MIL-M-28787/178B
AMENDMENT 2
31 March 1993
SUPERSEDING
AMENDMENT 1
14 September 1984

*MODULES, STANDARD ELECTRONIC

DRIVER, FET, SWITCH, DIGITAL, KEY CODE GDP

FIGURE 5. Isolation test circuit for table III.

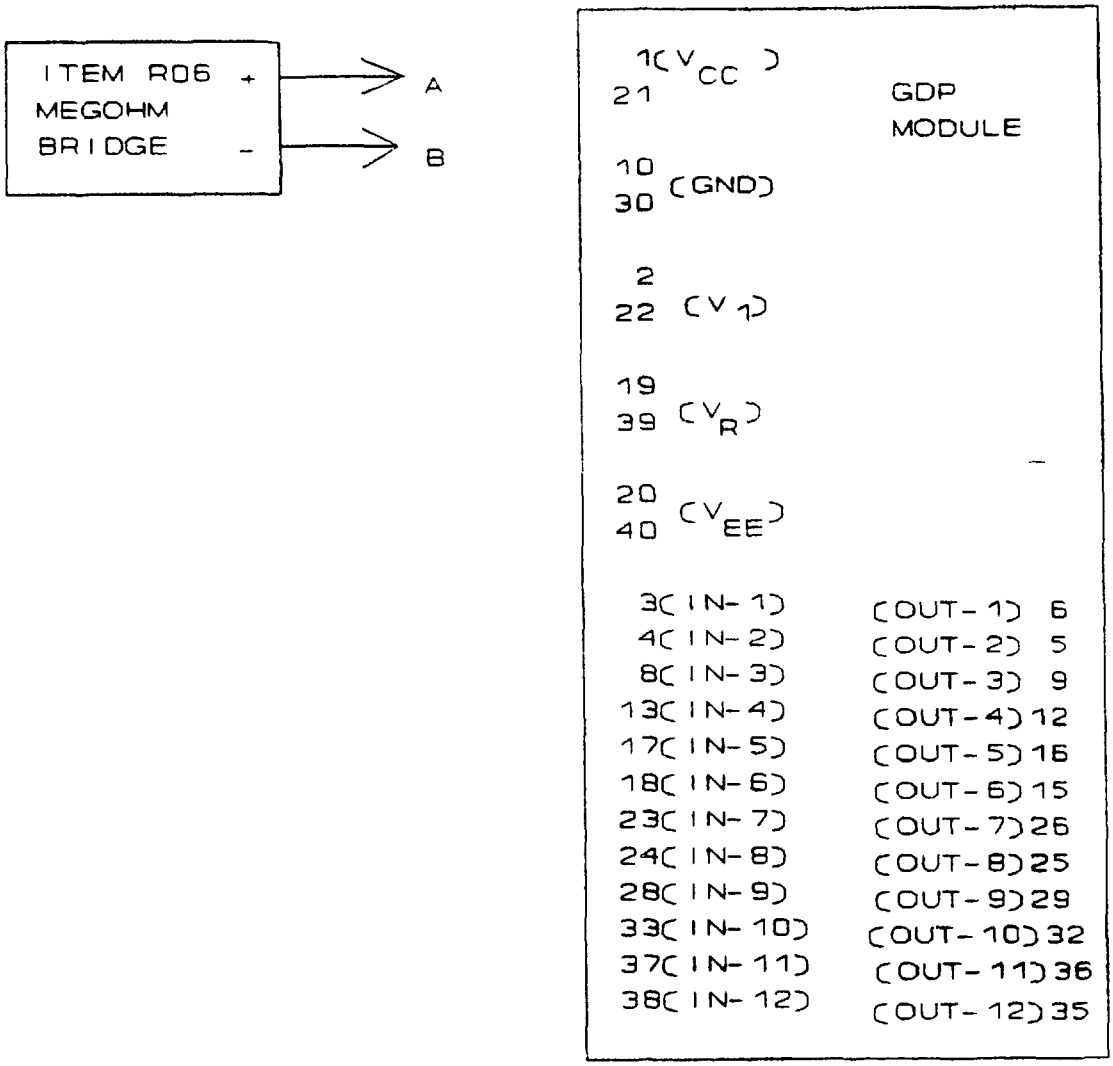
*FIGURE 5: Delete and substitute new figure 5 as printed on page 3 of this amendment.

1. **For test condition C1, the megohm bridge voltage shall be 100 ± 10 Vdc.**
2. **For test conditions C2 through C7, the megohm bridge voltage shall be 30 ± 3 Vdc.**
3. **For test condition C1, penetrate the anodized finish on the module frame with a sharply pointed probe connected to the negative terminal.**
